Subject ▶ Addition of dust cover

For Models ▶ 6904V, 6904VH and 6904H

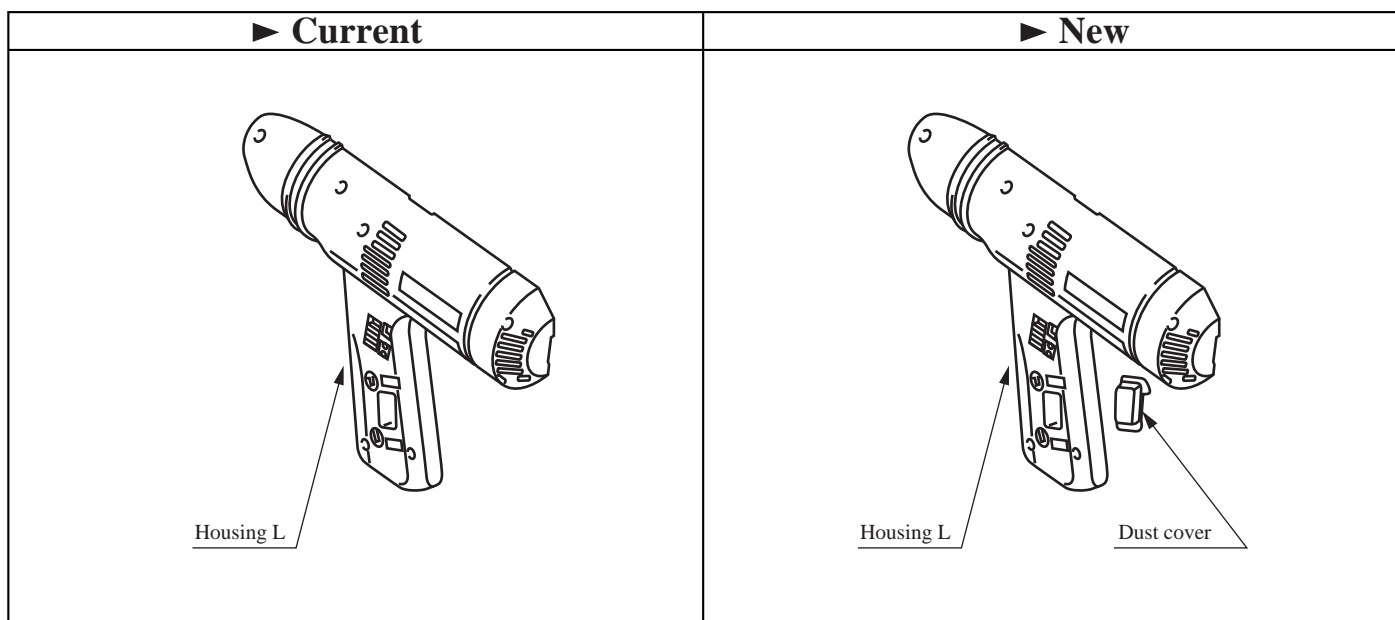
Description ▶ A dust cover will be added to the housing L to protect the reversing switch from dust.

Item No.	Current part		Q'ty	I/C	New part		Q'ty	Note
8					Dust cover 421460-7		1	For 6904VH and 6904V Interchangeable as a set
8	Housing set 182729-1		1	<=	Housing set (with dust cover) 182811-6		1	
8	Housing set 182728-3		1	<=	Housing set (with dust cover) 182812-4		1
